# REPORT SUMMARY MINOR VARIANCE APPLICATION FILE NUMBER A050/24

CITY WARD #:	2
APPLICANT:	Giuseppe Roti, Rosaria Roti & Daniela Roti
AGENT:	Marco Vieira & Patricia Santos
PROPERTY:	53 Hayhoe Avenue, Woodbridge
ZONING DESIGNATION:	See below.
VAUGHAN OFFICIAL PLAN (2010) DESIGNATION:	City of Vaughan Official Plan 2010 ('VOP 2010'): "Low-Rise Residential"
RELATED DEVELOPMENT APPLICATIONS:	None
AFFLICATIONS.	
PURPOSE OF APPLICATION:	Relief from the Zoning By-law is being requested to permit a proposed dwelling (including canopy and architectural feature) and increased maximum driveway width.

PROPOSED NEW DWELLING

> 53 HAYHOE AVENUE CITY OF VAUGHAN

SITE PLAN

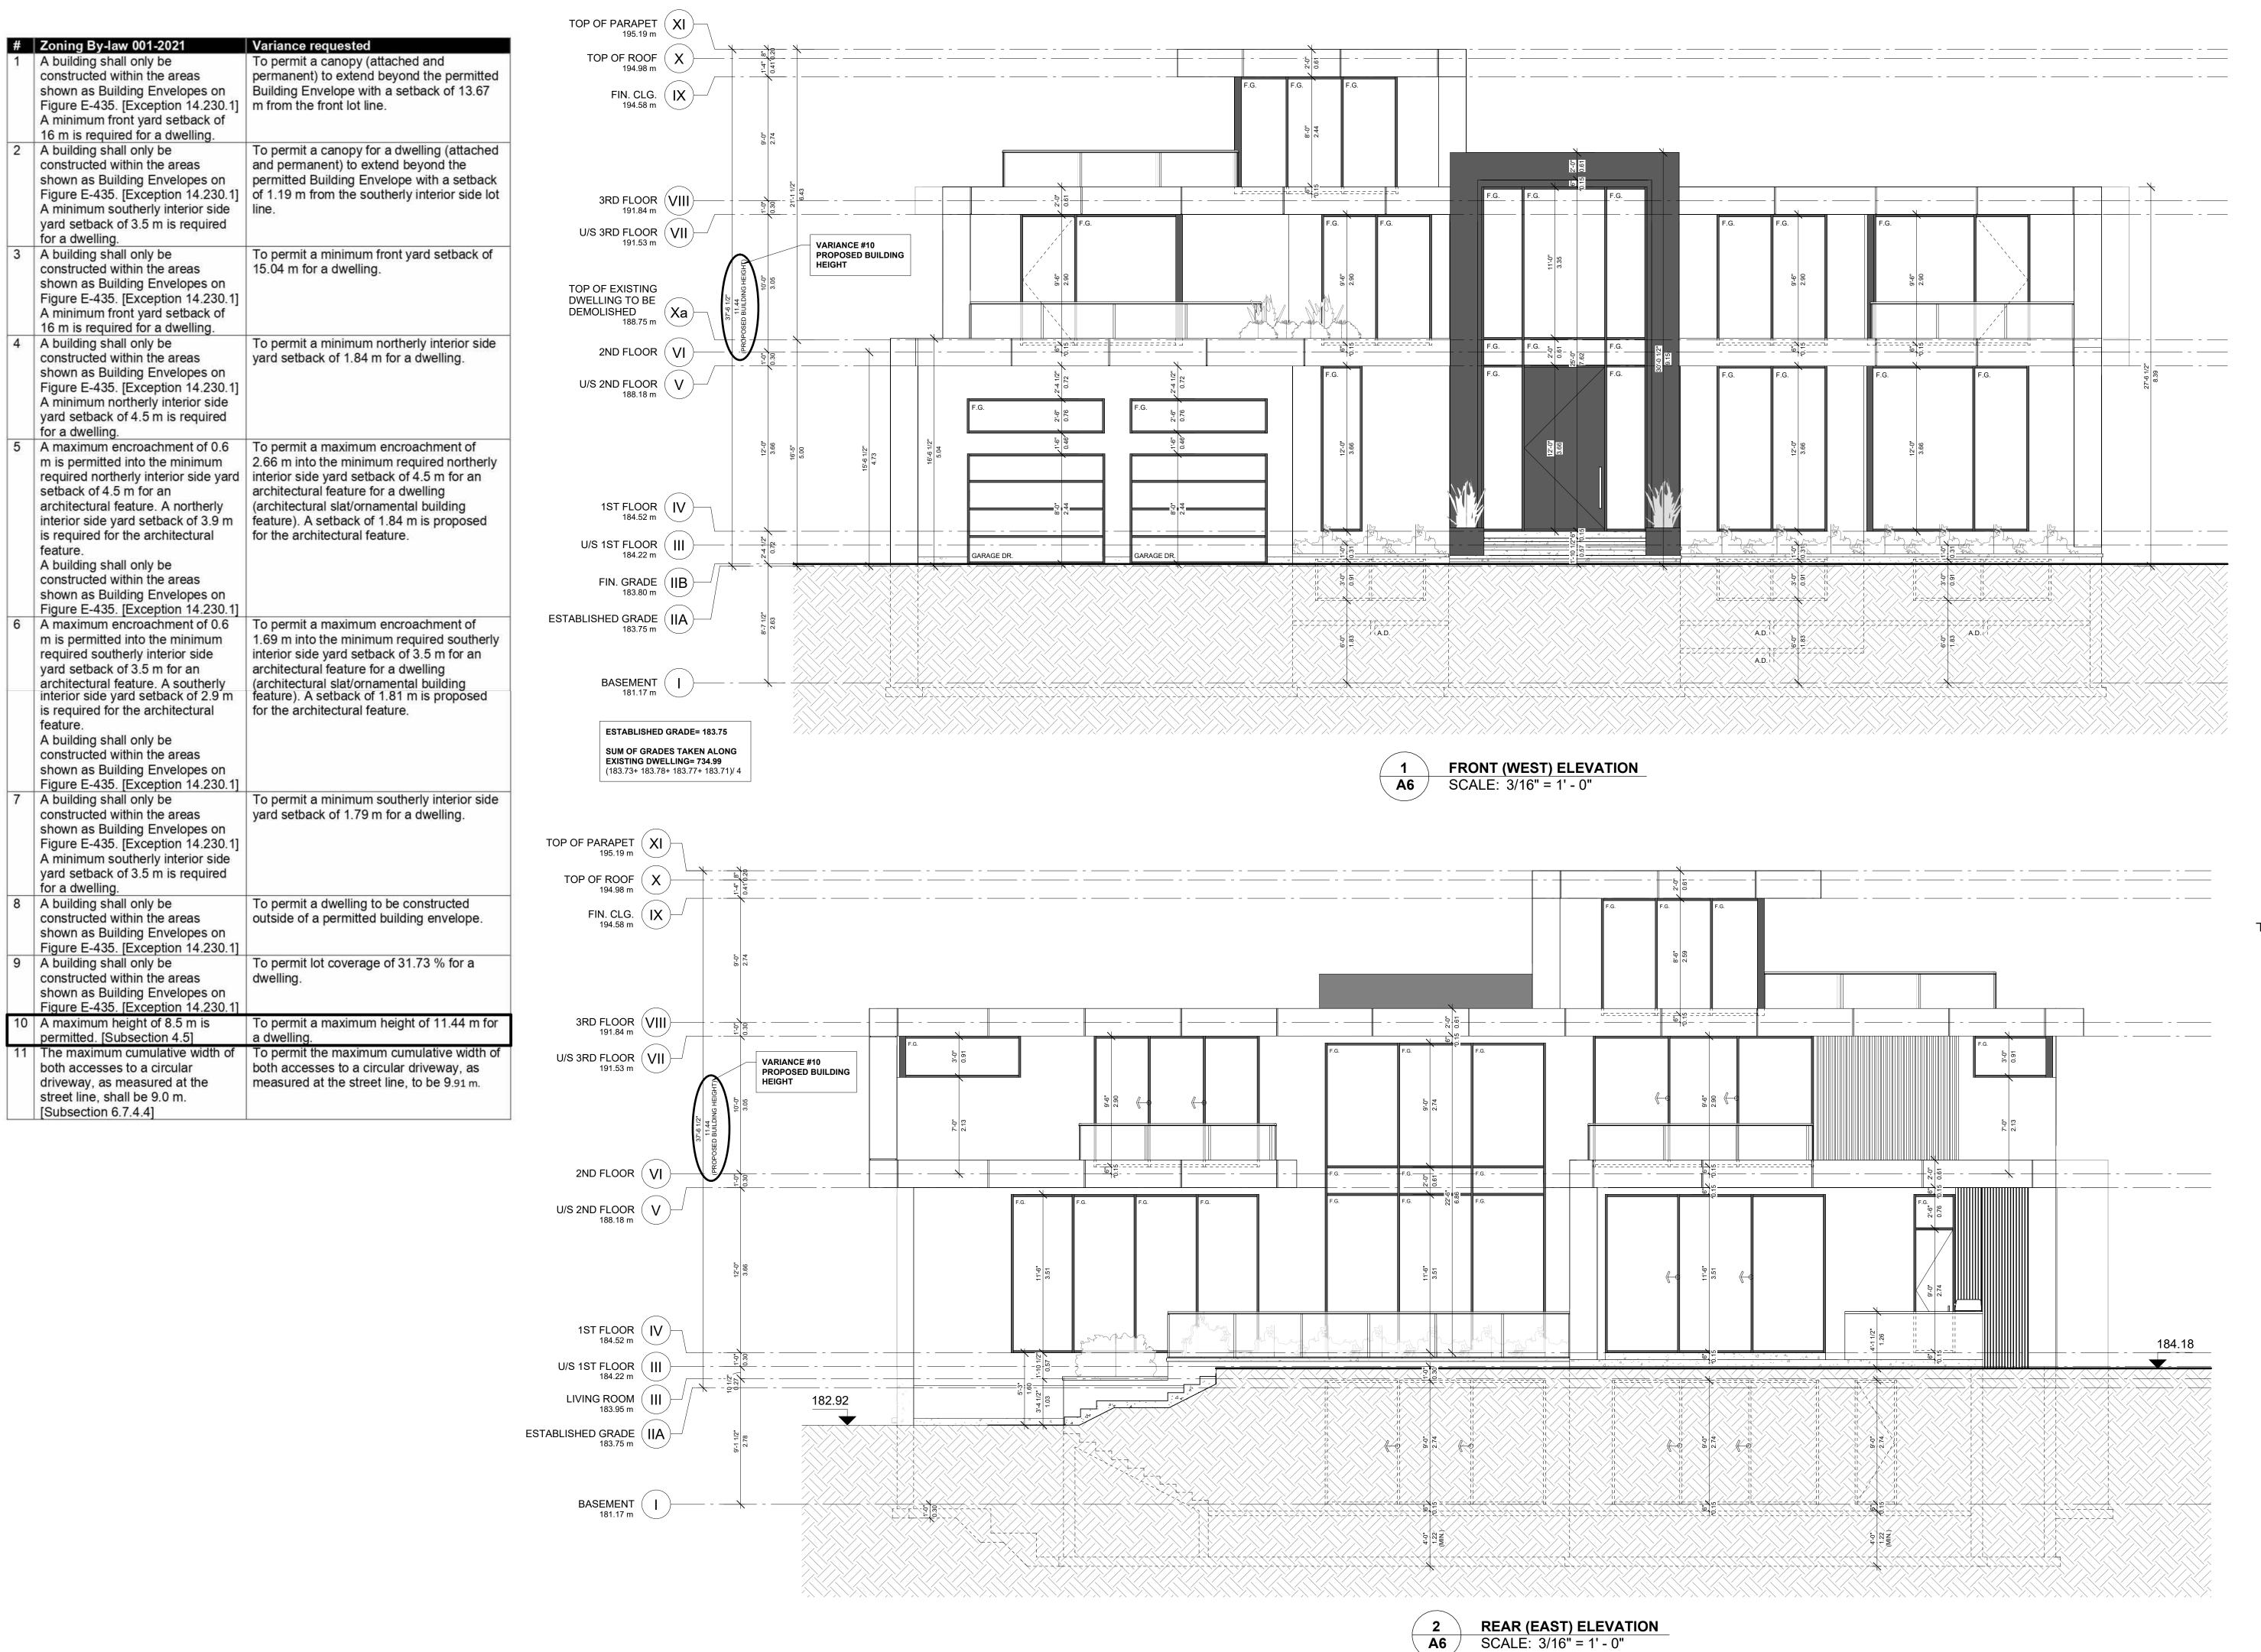
Zoi	ning By-law 001-2021
1	The Applicant shall be advised that the 19.26 m2 wood platform with privacy screen shall remain an Uncovered Platform and not a Building, as defined in Section 3.0 of the bylaw, or additional variances may be required. Please consult with By-Law Enforcement with respect to regulations regarding the privacy screen which is not regulated by the Zoning Bylaw.
2	The Applicant confirms that height of the proposed dwelling measured in accordance with Height and Established Grade, as defined in Section 3.0 of the bylaw.

Ge	neral Comments
1	The applicant shall be advised that additional variances may be required upon review of detailed drawing for building permit.
2	A one-foot reserve is shown abutting the front lot line on the Site Plan, which would impede access to the subject lands. The Applicant should contact the Engineering Department, City of Vaughan, for discussion.
3	Two kitchens are shown on the drawings the proposed dwelling. The Applicant shall be advised that Zoning review has been conducted for a single-family dwelling. A Secondary Suite has not been reviewed or authorized by this review.
4	Proposed walkway extends onto municipally owned lands. An Encroachment Agreement with the City of Vaughan may be required.

FRONT AND REAR ELEVATIONS

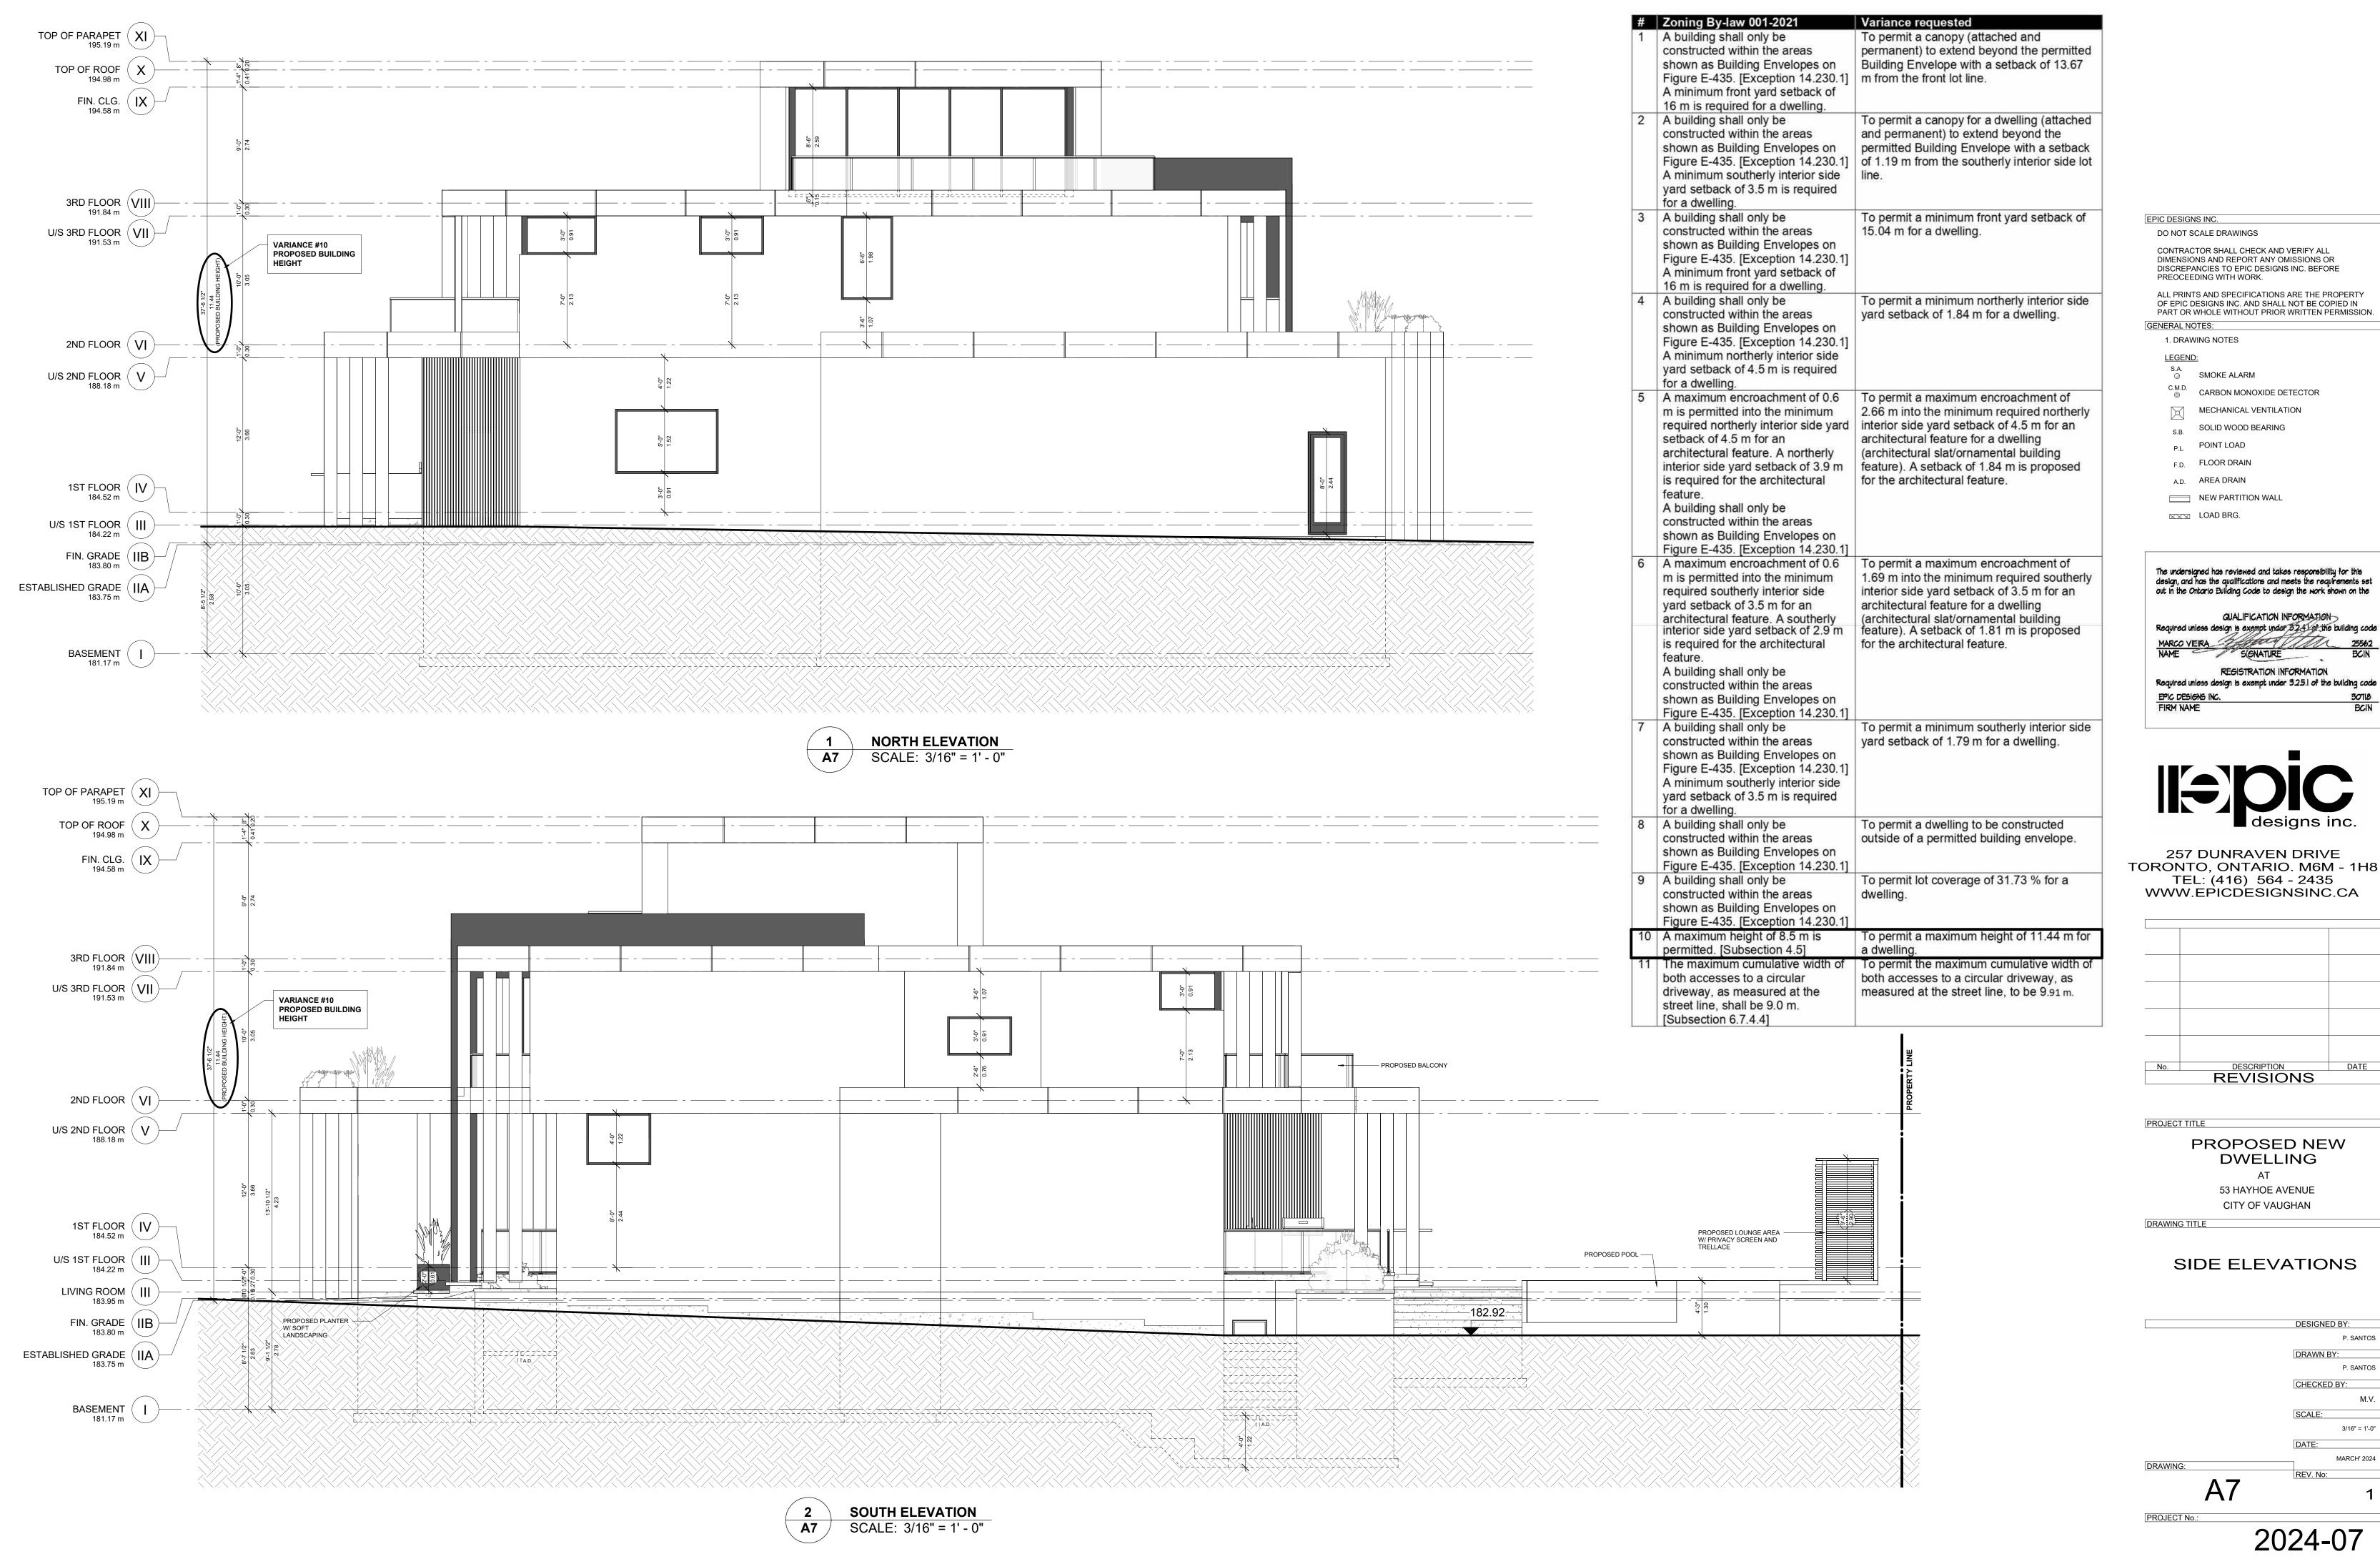
The Development Planning Department has no objection to Variance 8 to permit a maximum dwelling height of 11.44 m. The increased height is requested to accommodate the proposed dwelling's third storey. The third storey consists of an elevator and a recreational room, which also provides access to the outdoor green roof located above the second storey. The third storey is minimal in floor area and is substantially stepped back from all four sides of the dwelling, mitigating the overall massing impacts that the third storey will have on the public realm and its neighbours. The west (front), east (rear), north, and south side walls of the third storey are setback from the walls of the first storey by approximately 6.5 m, 5.7 m, 6.9 m, and 13.9 m respectively. While the first storey of the dwelling has a gross floor area (GFA) of 337.46 m², the third storey of the dwelling only has a total floor space of 35.47 m². Furthermore, the overall size of the dwelling does not represent an over-development of the lot as the setbacks and lot coverage are all compliant with the standards of the R1A Zone. Urban Design staff have reviewed the proposal and do not have any concerns with the maximum dwelling height.
